Property Alliance Group / Starwood Capital Group Renaissance Site

Residential Building Section 73 Application (141175/JO/2024)

Issue No. 03 23.10.25

5.2 Lower Ground -01
S73 Proposal

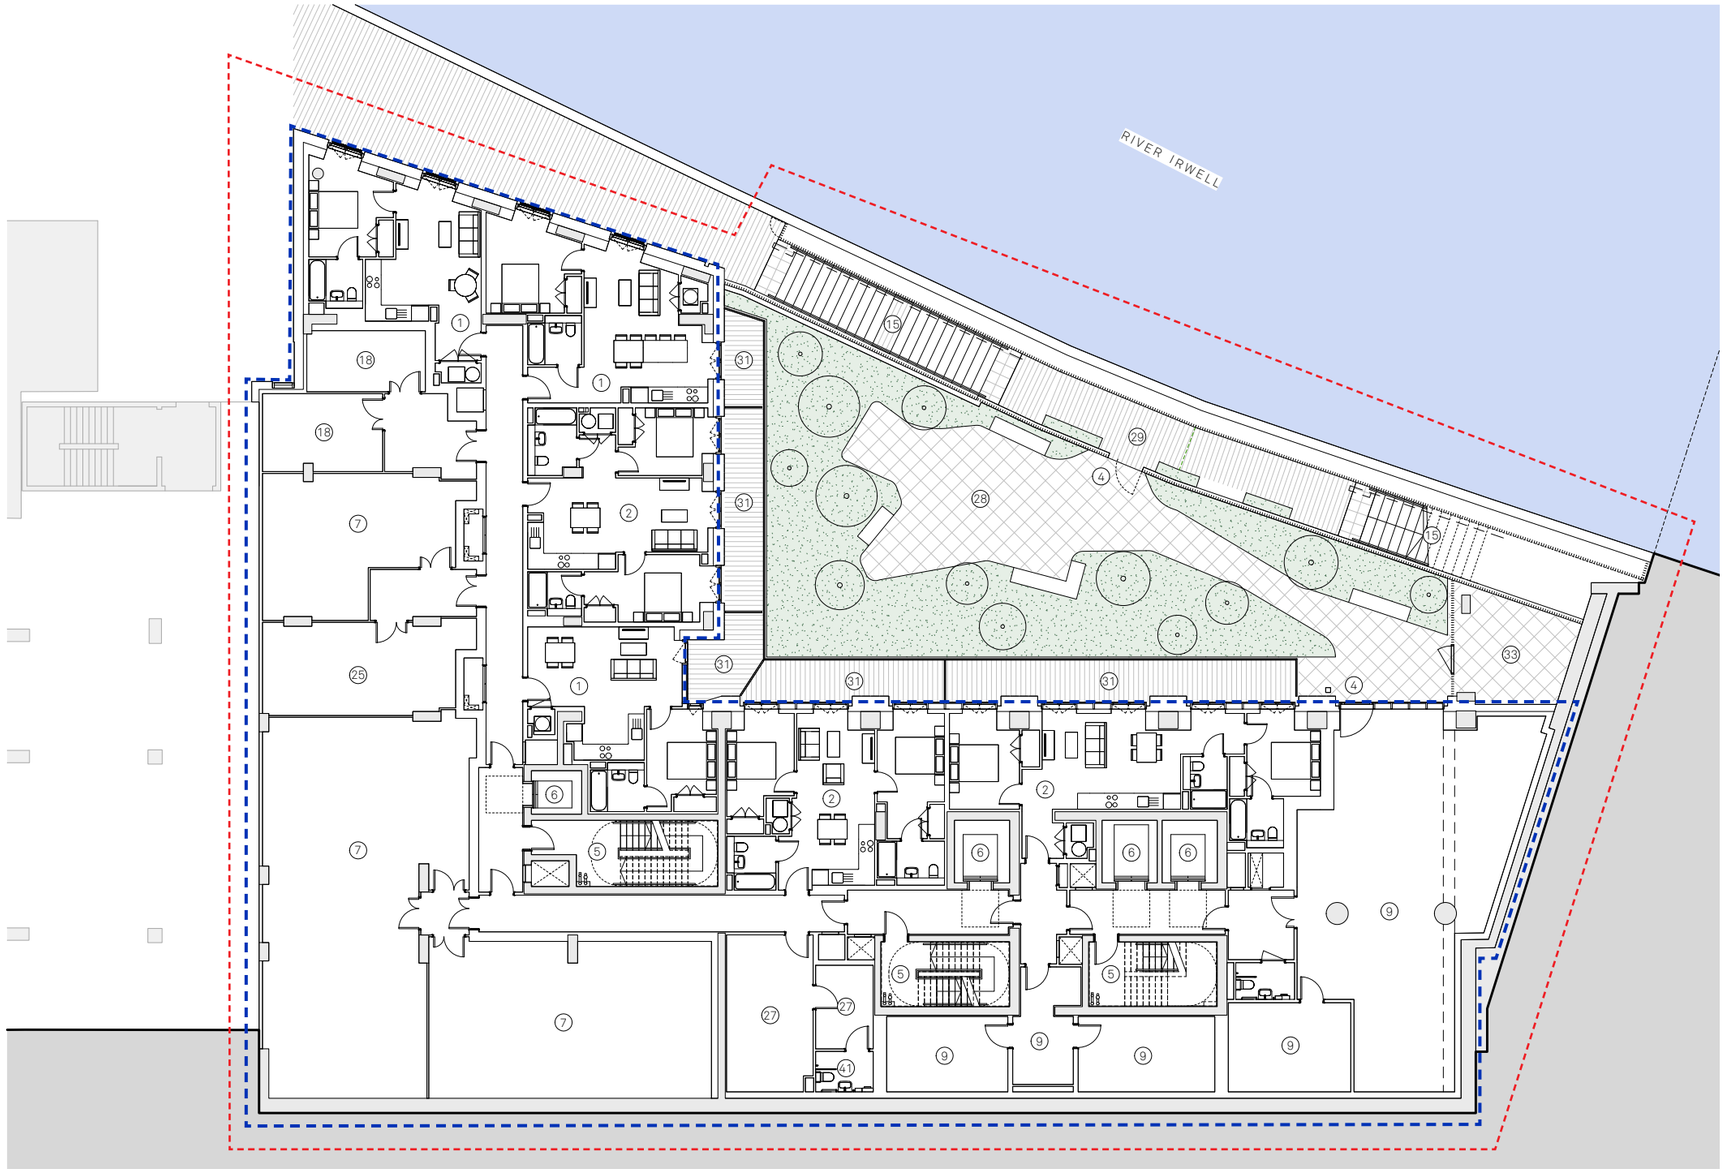
Sept 2024 Amendments:
(141175/JO/2024)
- Fire-fighting lobby added to all floors with an +1 additional stair and evacuation lift plus associated fire fighting lobbies.

Current Proposed Amendments 2025:
- Spatial reconfiguration of amenity, plant, operation and service rooms.
- All apartment layouts amended.
- Minor amendment to terrace landscaping at lower-ground 1
- Cycle store moved from lower-ground 1 to lower-ground 2
- Life safety plant room moved to lower-ground 1 from lower-ground 2.

5.2 Ground Floor
S73 Proposal

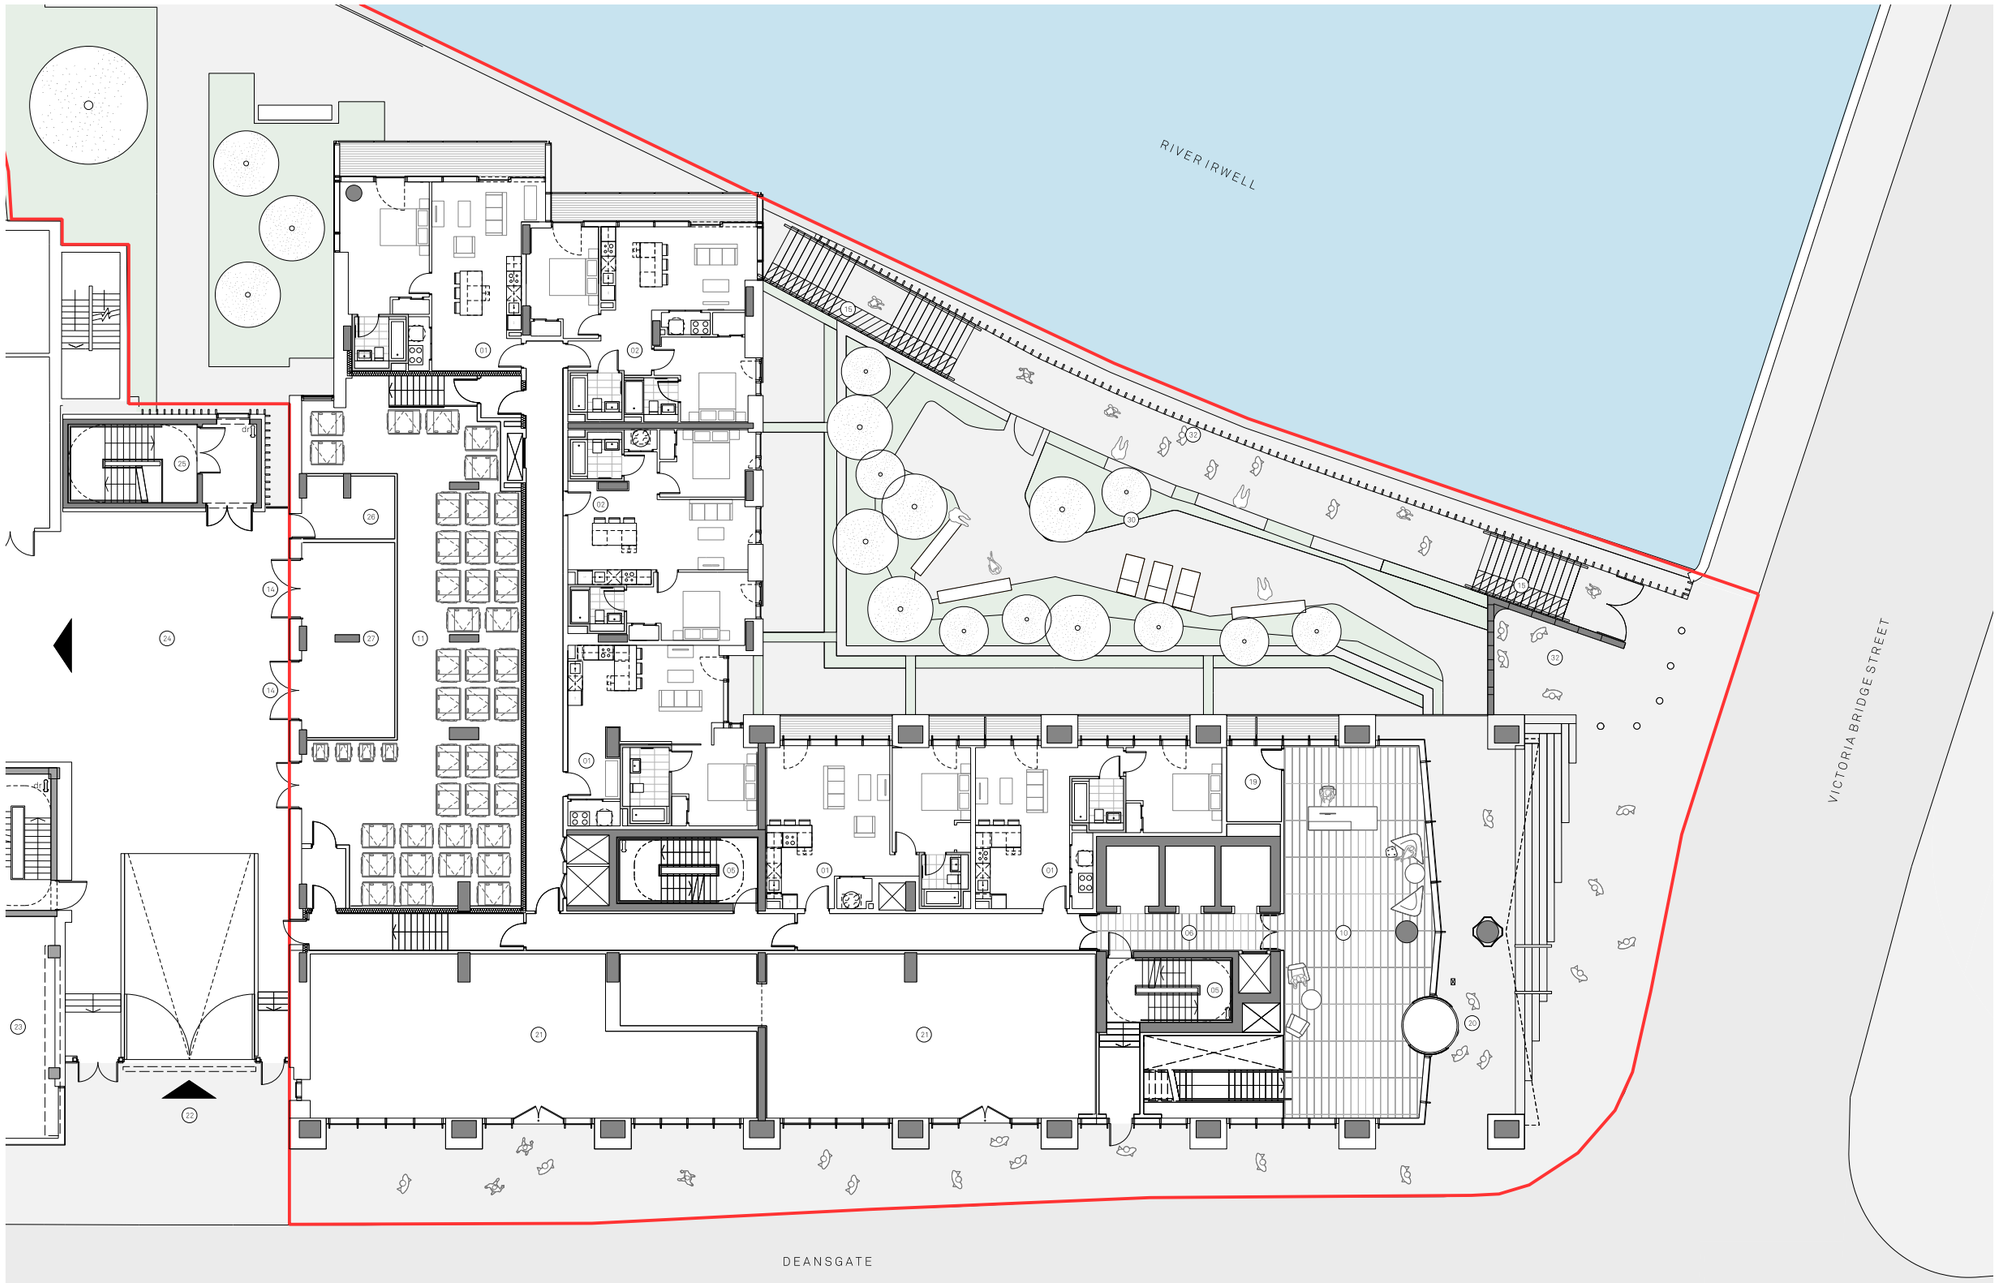
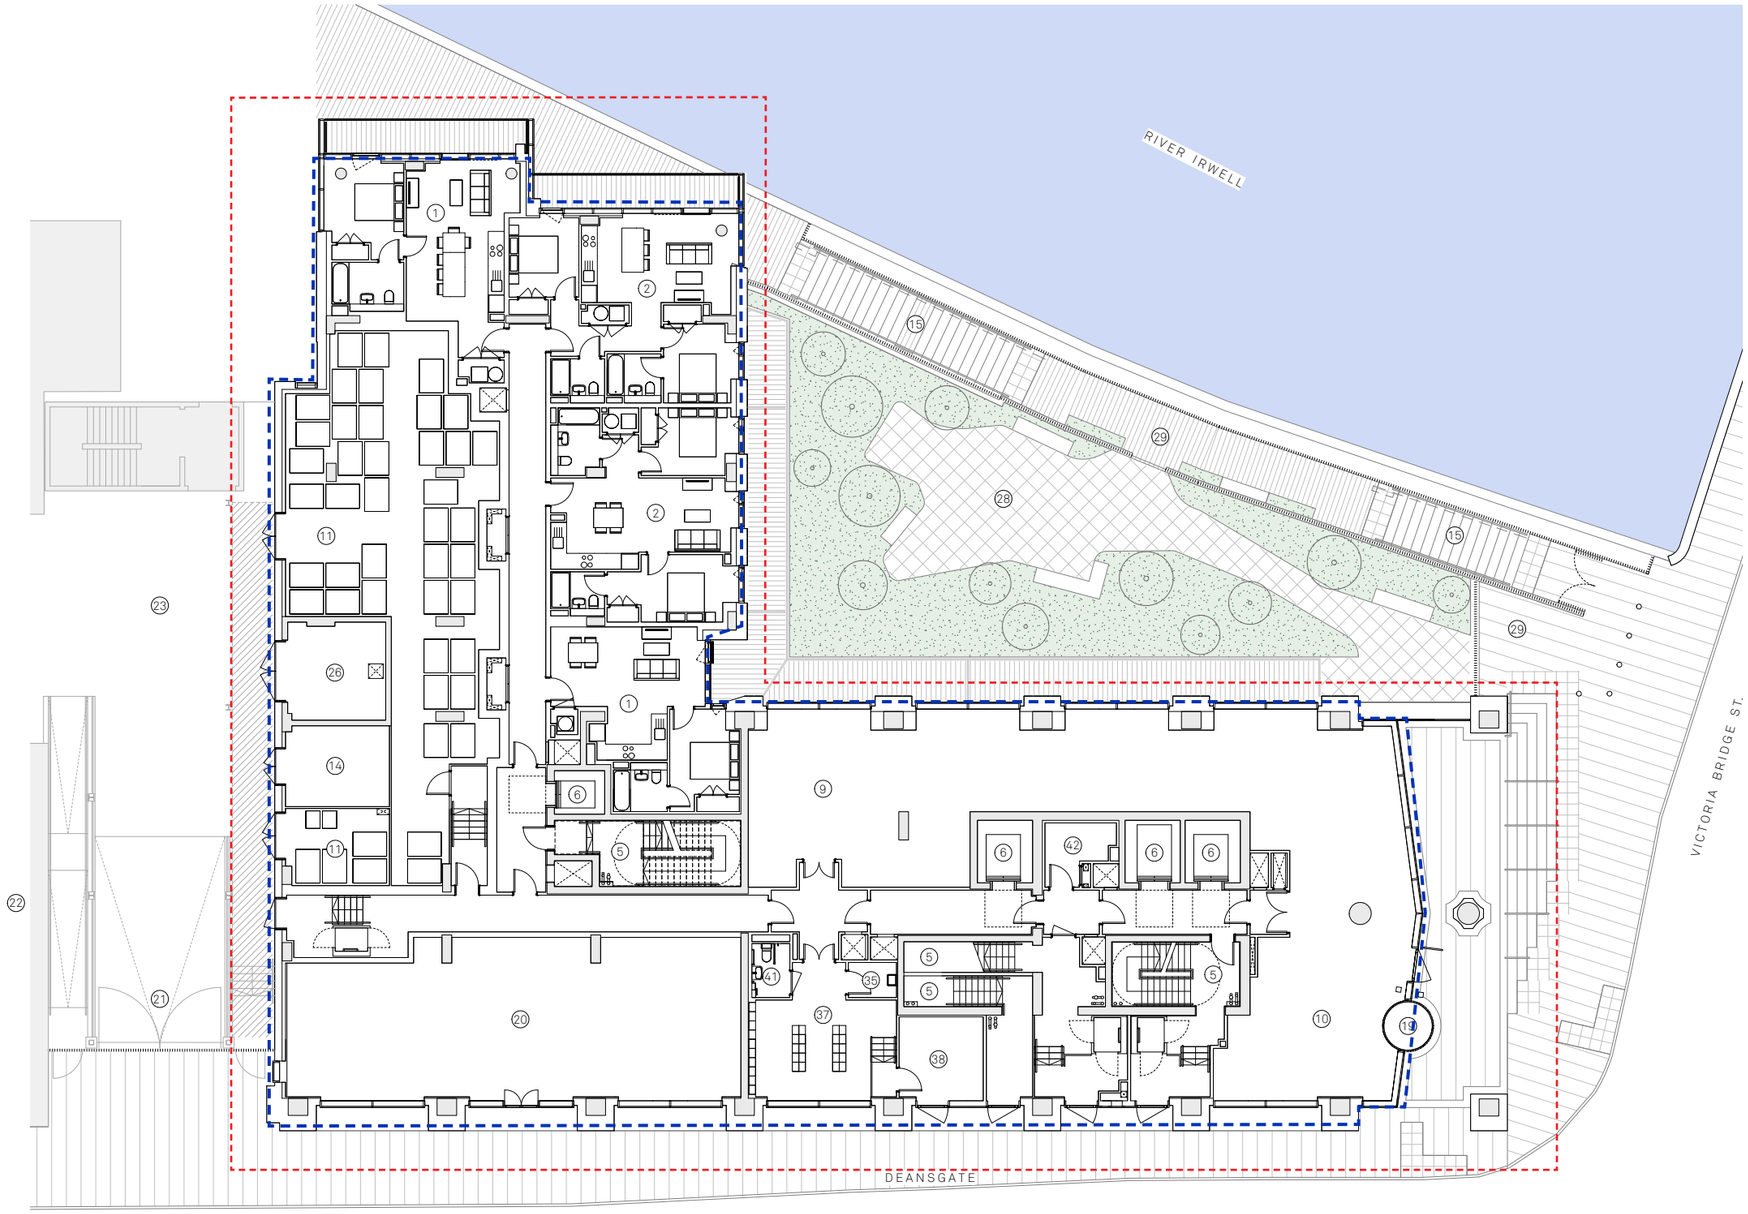
Sept 2024 Amendments:
(141175/JO/2024)

- Fire-fighting lobby added to all floors with an +1 additional stair and evacuation lift plus associated fire fighting lobbies.

- Spatial reconfiguration of amenity, plant, operation and service rooms.
- All apartment layouts amended.
- Removed ground floor terrace facing lower-ground 1 courtyard (River Irwell elevation)
- External doors to Service Yard to suit internal layouts

5.2 Level 01
S73 Proposal

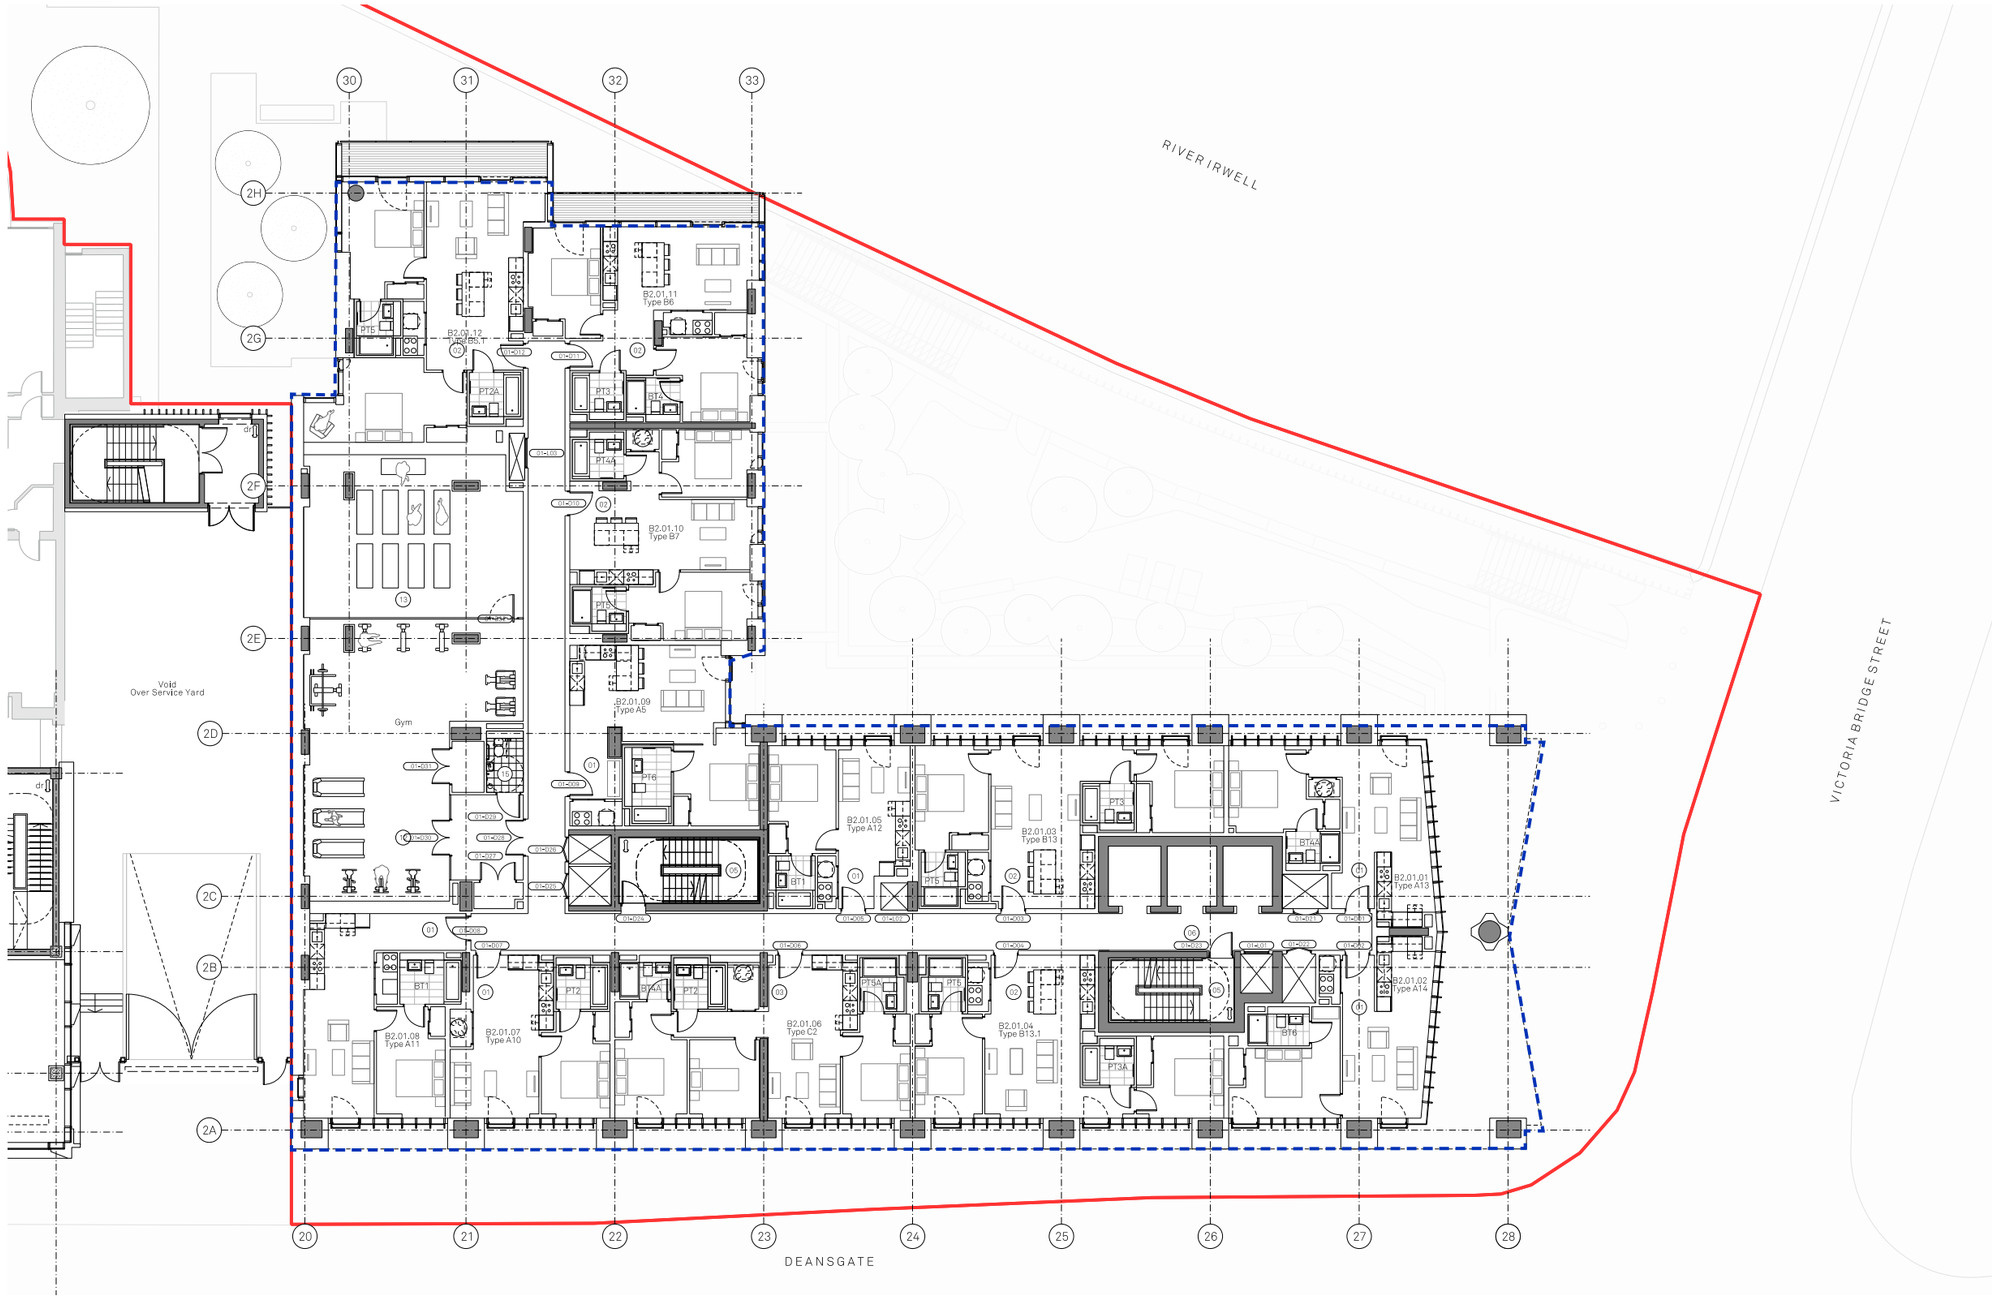
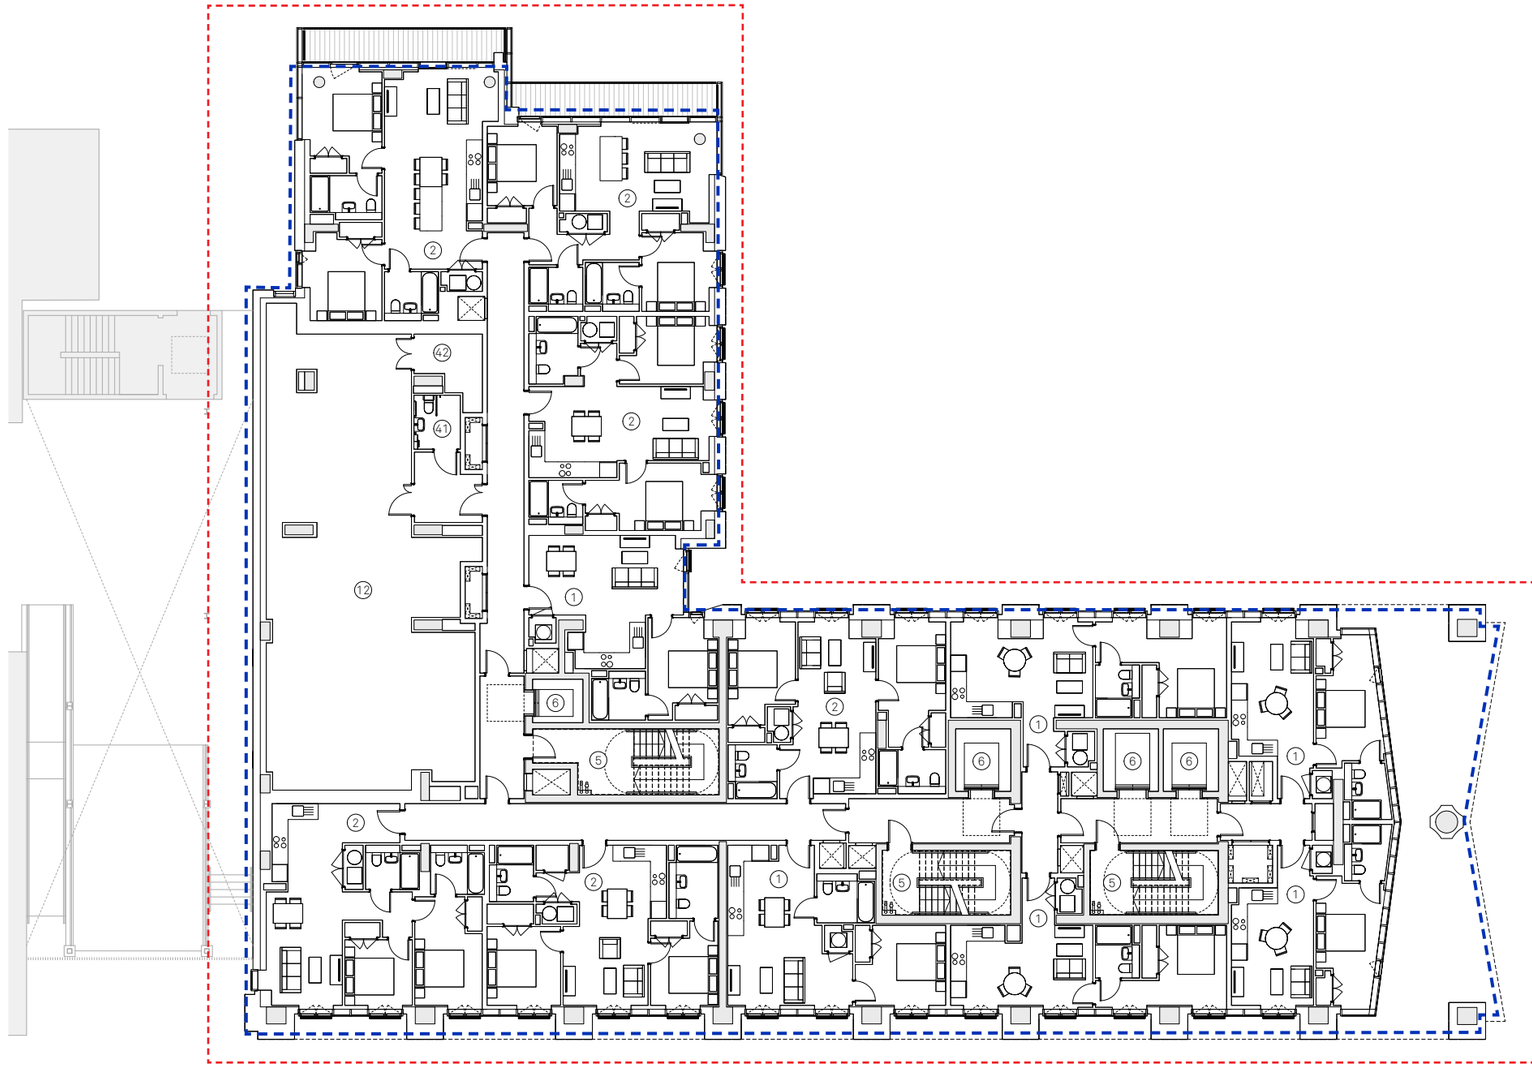
Sept 2024 Amendments:
(141175/JO/2024)
- Fire-fighting lobby added to all floors with an +1 additional stair and evacuation lift plus associated fire fighting lobbies.

Current Proposed Amendments 2025:
- Spatial reconfiguration of amenity, plant, operation and service rooms.
- All apartment layouts amended.
